STATE OF VERMONT
AGENCY OF TRANSPORTATION

RECORD PLANS

PROPOSED IMPROVEMENT
BRIDGE PROJECT

VT ROUTE 12, MAJOR COLLECTOR BRIDGE NO : 25

TEST PAD

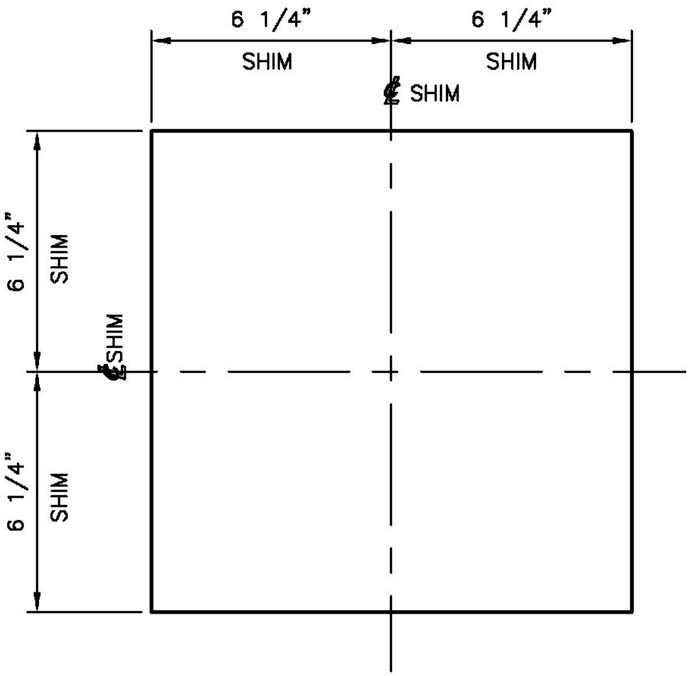
APPROVER PLEASE PROVIDE
LOAD CRITERIA FOR TESTING

Vermont Agency of Transportation
RECEIVED
CK'D BY WL OK'D BY JS
December 2, 2013
RESUBMIT NO Approved AsNoted
BY KH DATE 12-3-2013

ABUTMENT & WING WALL LAYOUT

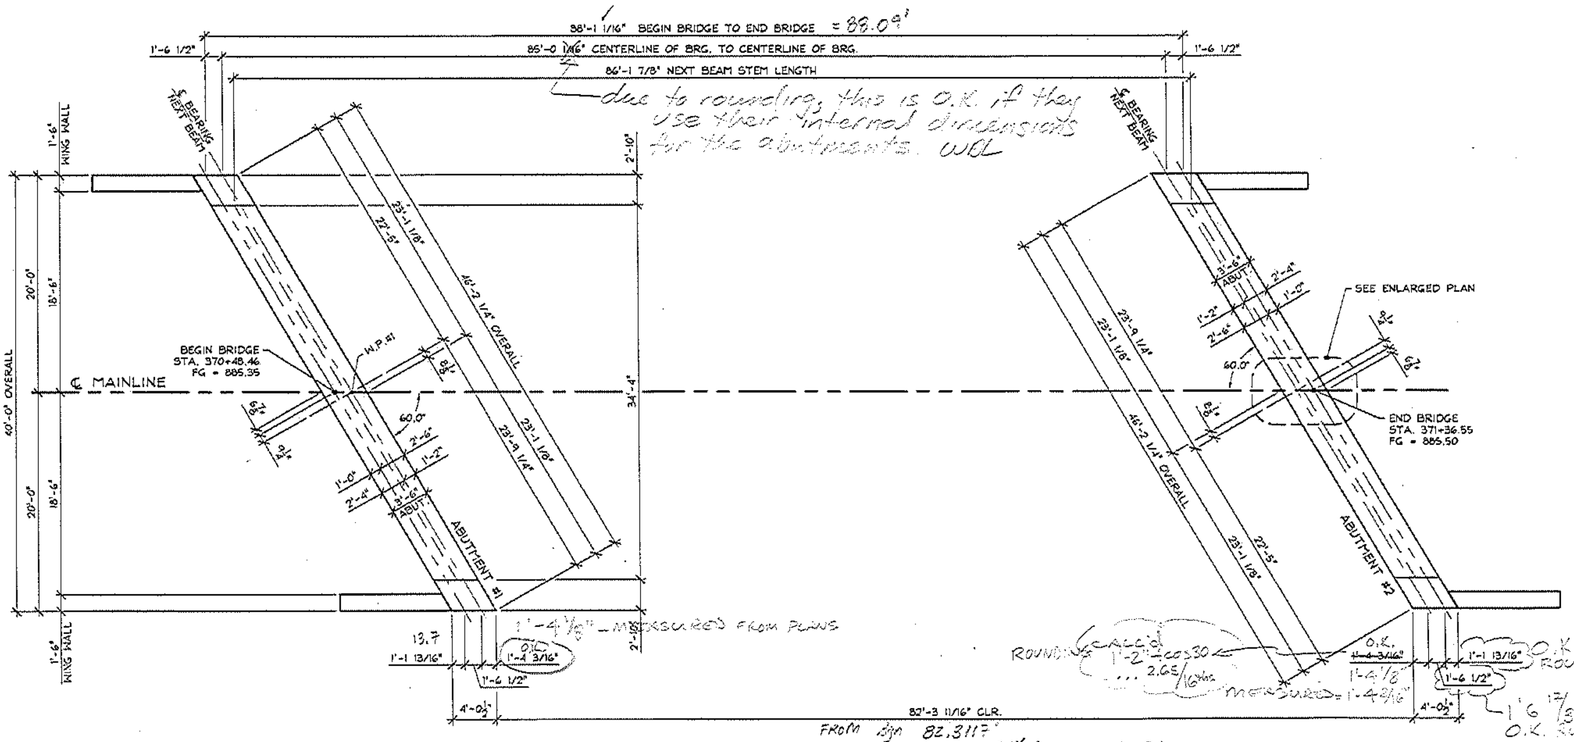
1/16" → 1/32" OFF ~ ROUNDING ISSUE

MEASURED FROM MICROSTATION:
85.0000' ON PLANS = 85'-0 1/16"
℄ - ℄

FROM CONTRACT PLANS
$\℄_{BRG} - \℄_{BRG} = (371+35.00) - (370+50.00) = 85'$
(BEG BRIDGE ↔ END BRIDGE) − (℄ BRG ↔ ℄ BRG) = 3' 1 1/16"
÷2
℄ BRG ↔ B/E BRIDGE = 1' 6 17/32"

ENLARGED PLAN

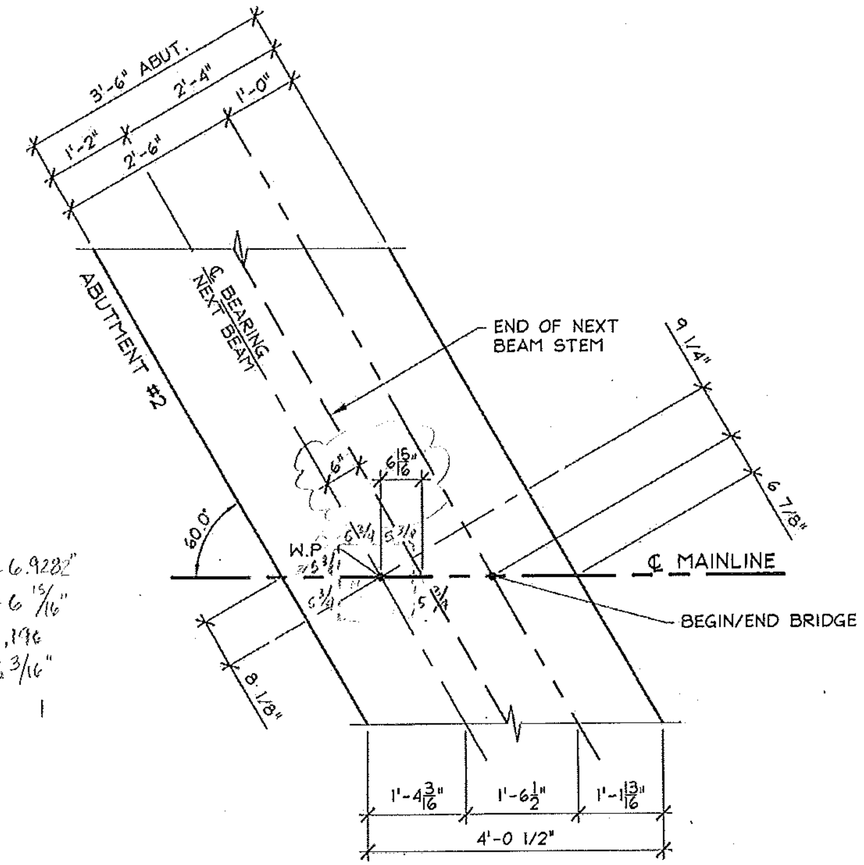
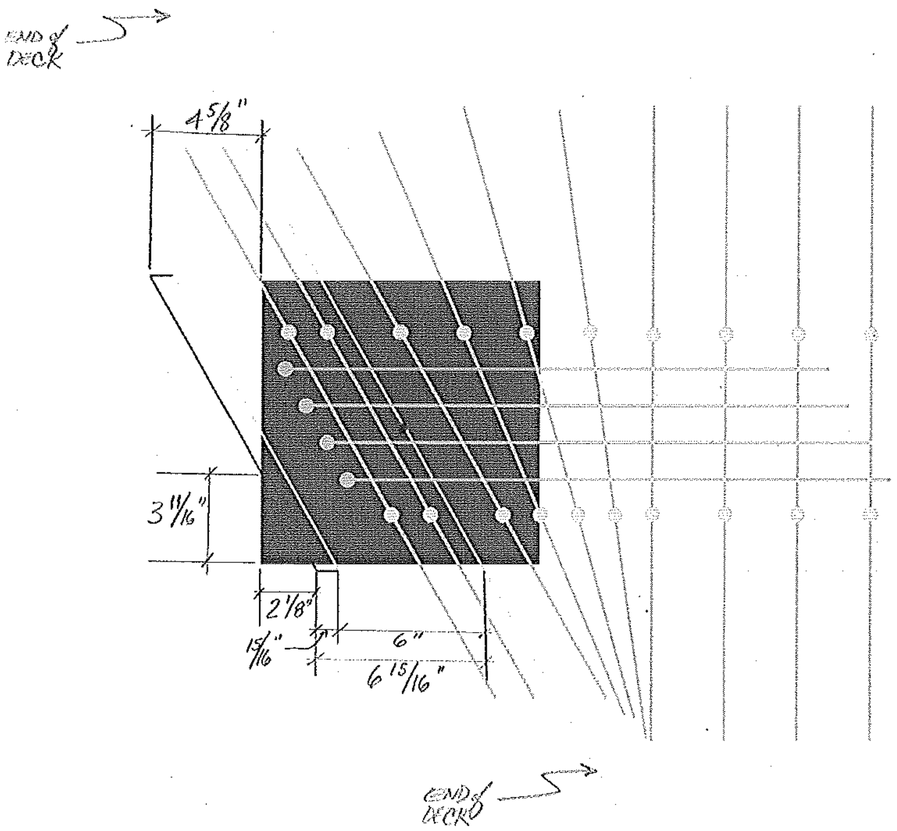
BEARING STILL STICKS OUT @ obtuse CORNER by 2 1/8"

CHECK AREA UNDER BEAM - SEE IF THAT SUPPORTS LOADS

$(11.5\,in)^2 - \frac{1}{2}(3\frac{11}{16}\,in)(2\frac{1}{8}\,in) =$
